Dubbo Project Modification 1

Project Layout and Processing Changes

State Significant Development Modification Assessment
(SSD 5251 MOD 1)

March 2023

Figure 3 | Proposed Site Layout (Source: MOD 1 Submissions Report, RW Corkery)

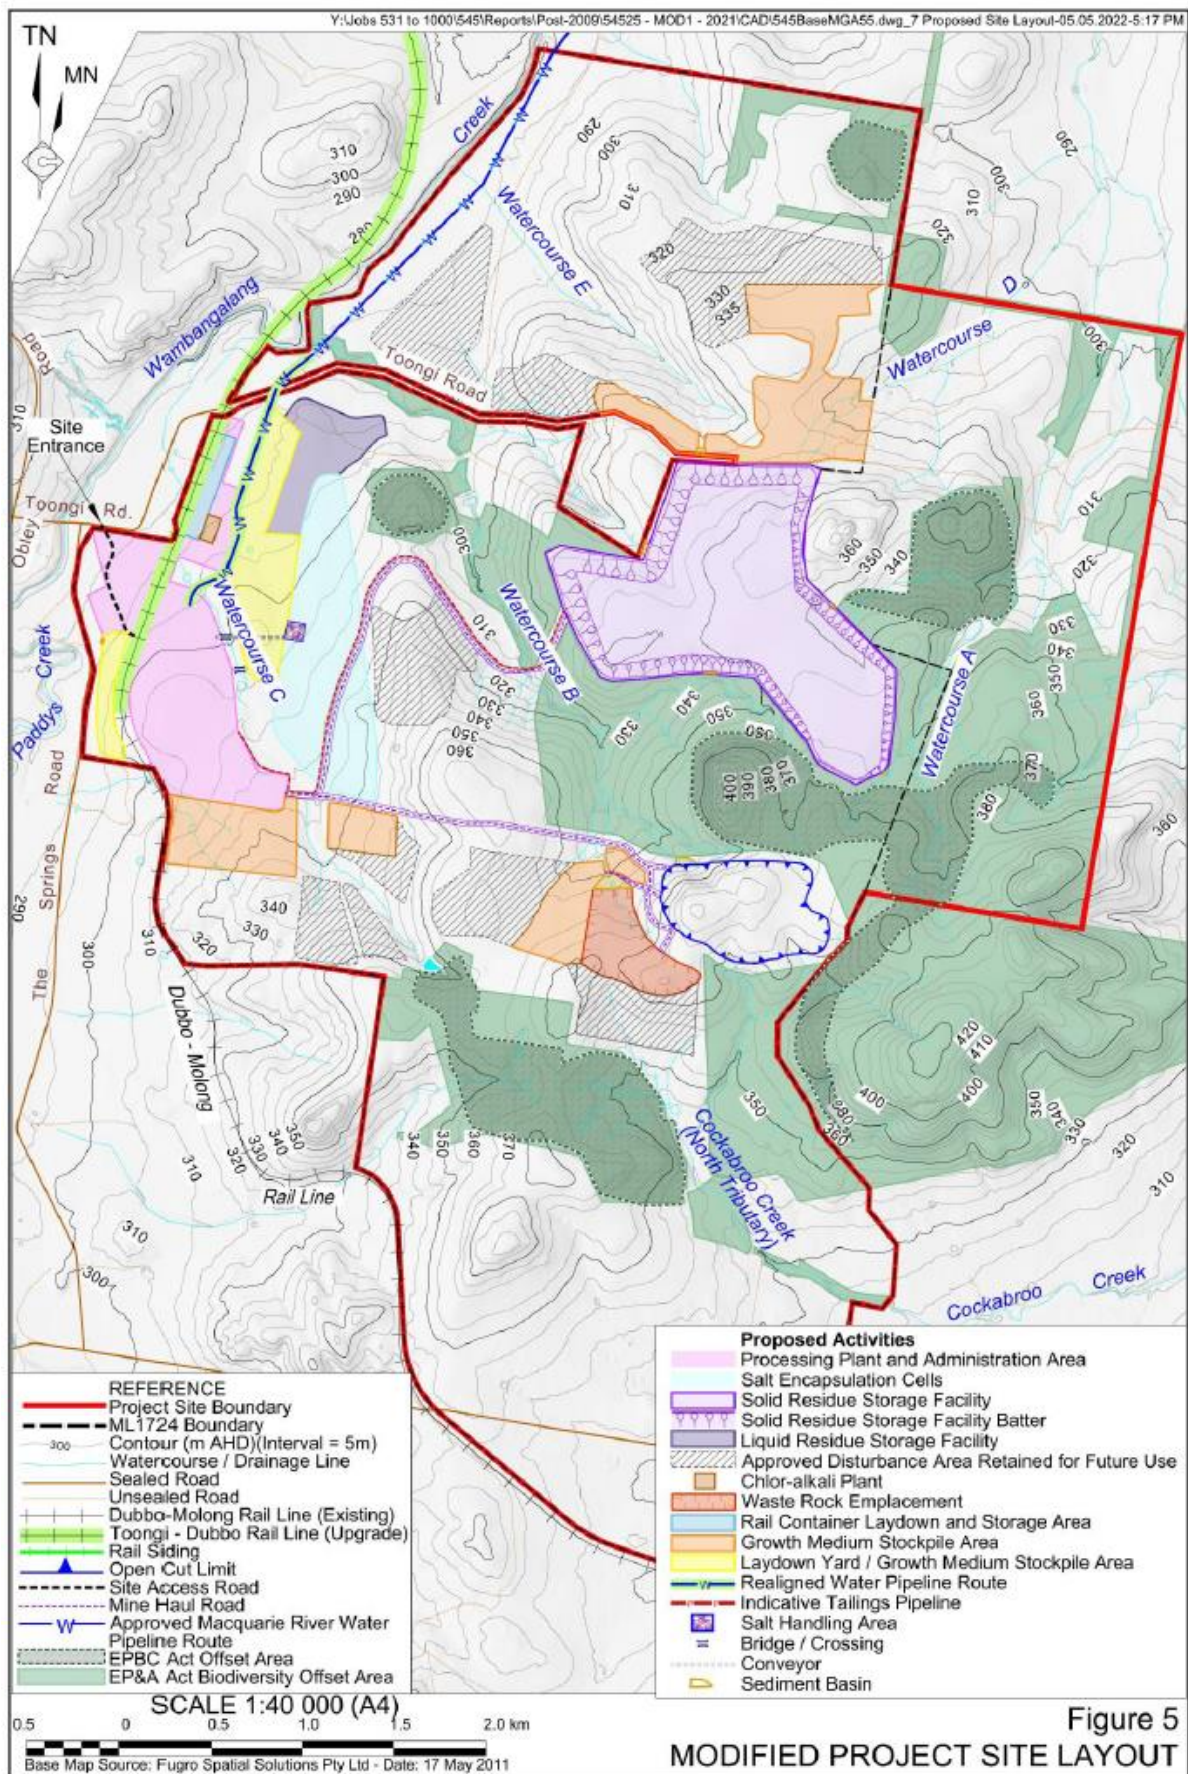
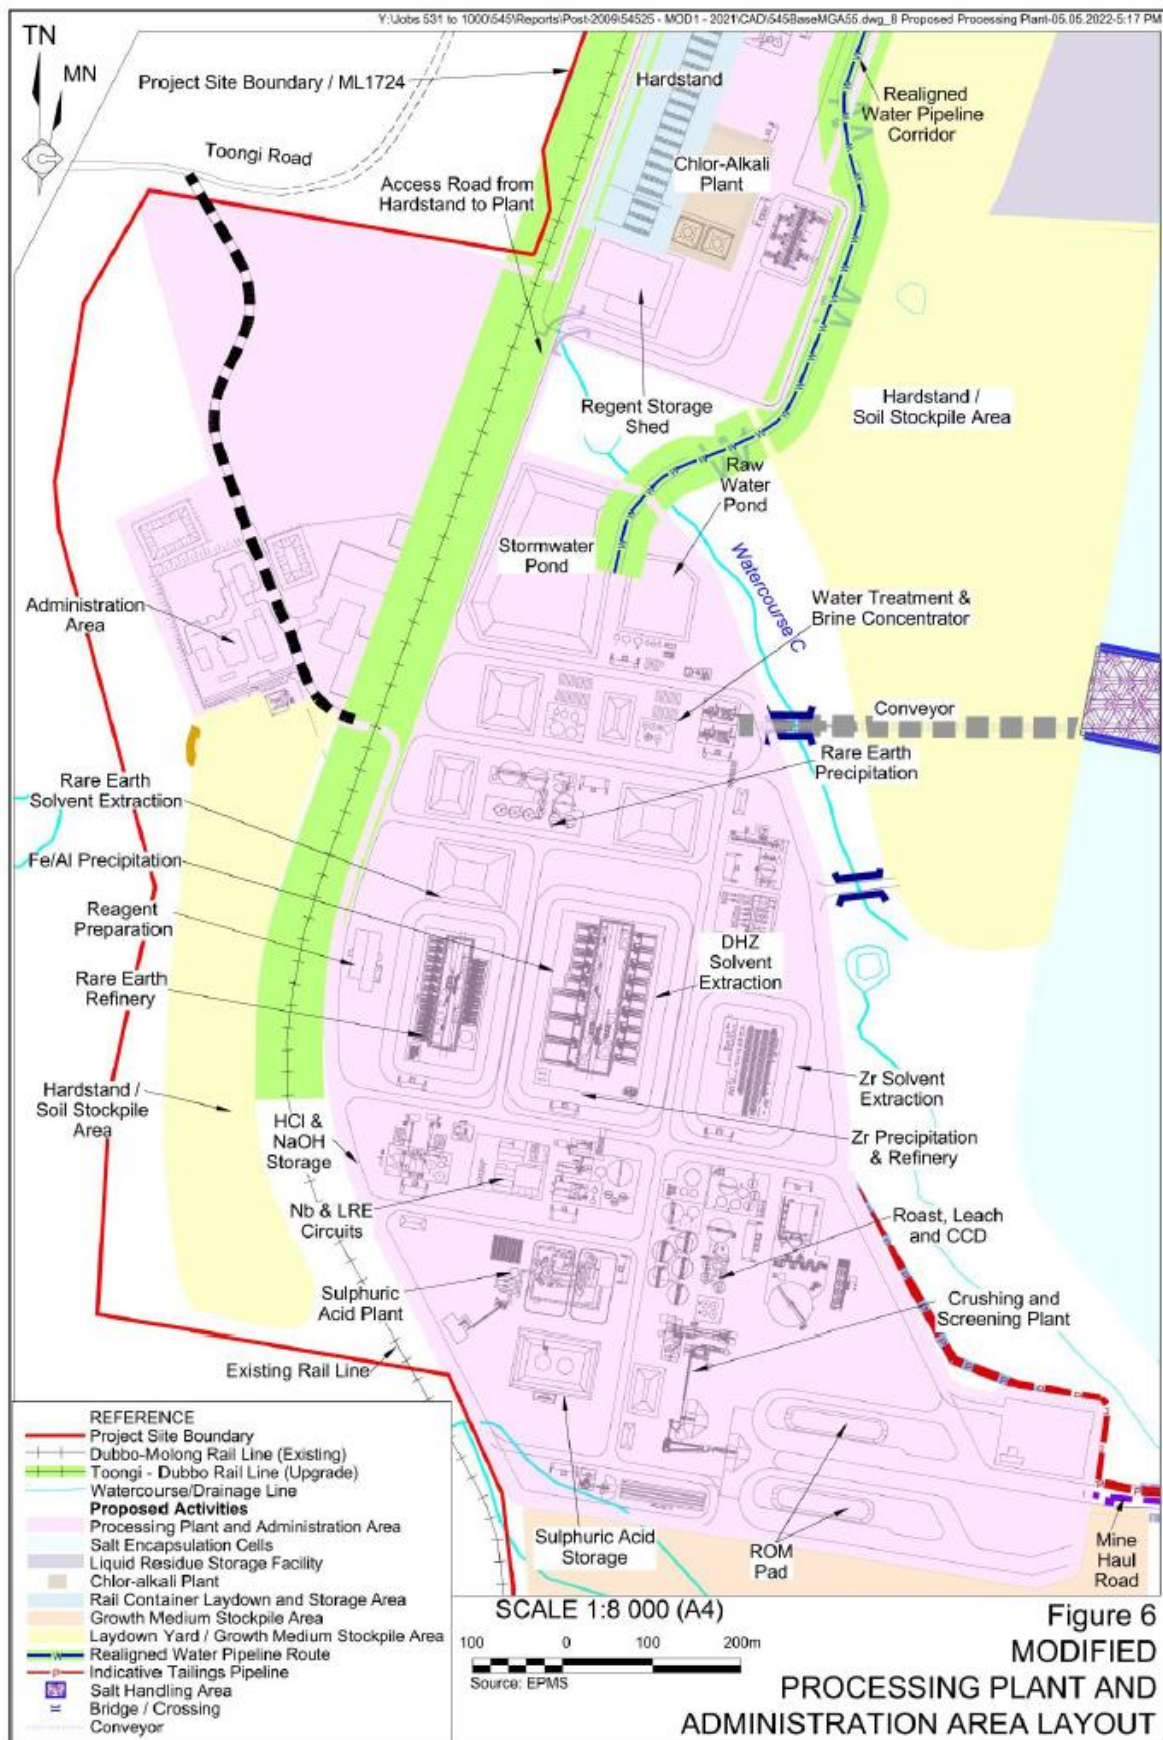
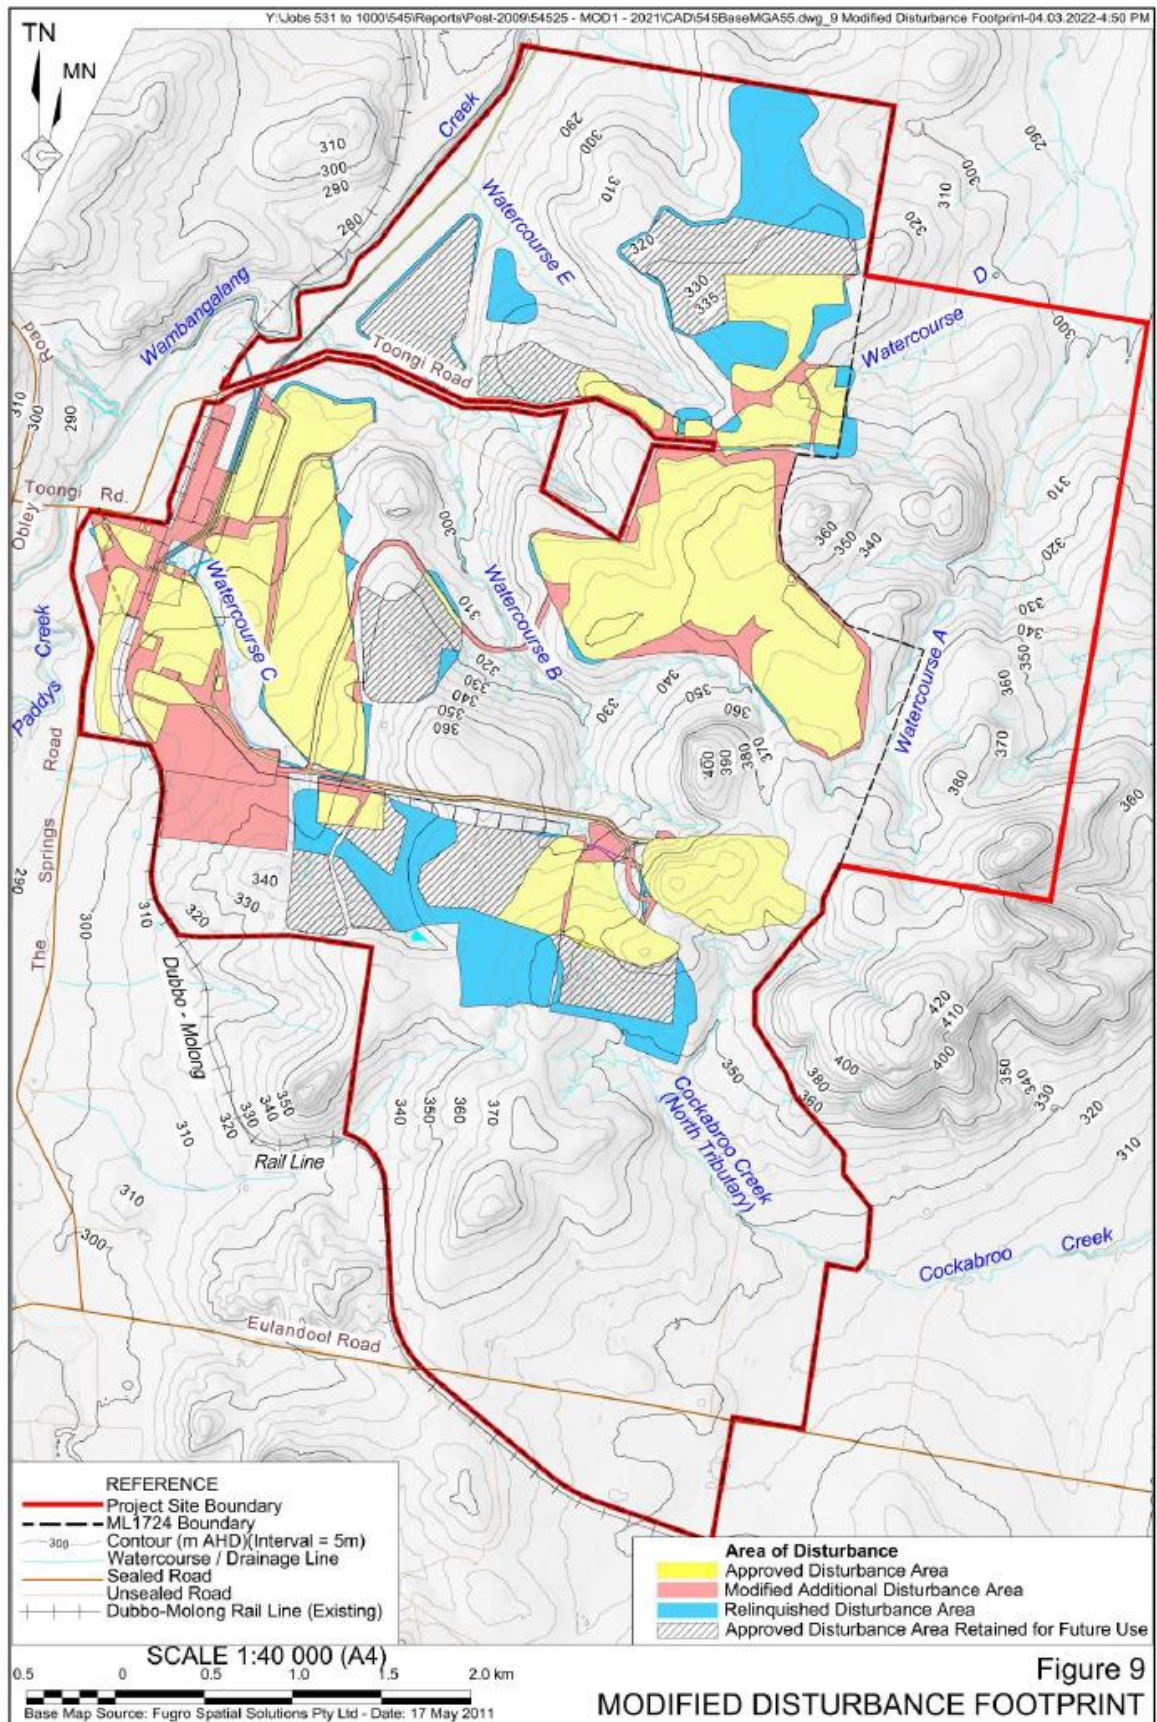
The proposed modification would not change the mining methods or annual extraction rate and is summarised in **Table 1** below and depicted in **Figures 3, 4 and 5**. The proposal is described in detail in the Modification Report (see **Appendix A1**). The key modification elements include:

- **Processing plant upgrades:** to provide for further value adding of rare earth oxide products including a chlor-alkali plant to produce chemical products for processing (hydrochloric acid and sodium hydroxide).
- **Relocation of rail infrastructure:** to facilitate more efficient unloading and loading of containers
- **Waste management upgrades:** including a brine concentrator to maximise water recovery, with consequent changes to the footprint of the solid and liquid residue storage facilities and the salt encapsulation cells
